# UNITED STATES PATENT AND TRADEMARK OFFICE

APPLICATION NO.	FILING DATE	FIRST NAMED INVENTOR	ATTORNEY DOCKET NO.	CONFIRMATION NO.
10/600,379	06/20/2003	Steve B. Taylor	2236.001	7549

## Office Action Summary

Patent 5697320 (see marked-up figures below).

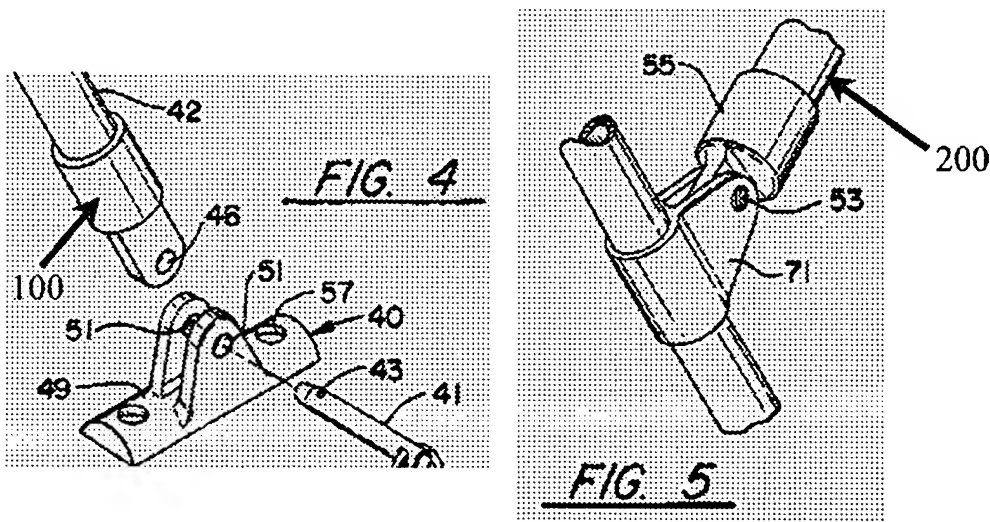
Claims 1-3 are rejected under 35 U.S.C. 102(b) as being anticipated by Murray U.S.

Claim 1. Murray discloses (figs. 1, 4, 5) a variably positionable coupler mountable on a curved surface, comprising: a base (40) formed with an upper side and a lower side, wherein the lower side is a substantially flat planar surface; means (57) for mounting the base on the curved surface; a tub (100) adjustably connectable to the base; a plug (42, 71) repositionably attachable to the tub; a neck (55) rotatably insertable in the plug, wherein the neck is formed for securing a

shaft (200) to the neck; and a clevis mechanism (clevis connection between 55 and 71) slidably and demountably engageable with the plug and the neck. (Note that while the Murray curved surface does not curve at its point of contact with element 40, it does curve elsewhere and is thus a curved surface within the broadest reasonable interpretation of the claim language).

Claim 2. Murray discloses opposing yokes (tab portions of 40 receiving 41) monolithically extending at substantially right angles from the upper side of the base.

Claim 3. Murray discloses one or more bores (51) formed in the base with a proximal end and a distal end, and further wherein the one or more bores are shaped for removable engagement with a bolt (41). The word "bolt" is taken by the examiner to mean, "a metal rod or pin for fastening objects together" in accordance with Merriam-Webster's Collegiate Dictionary Tenth Edition.
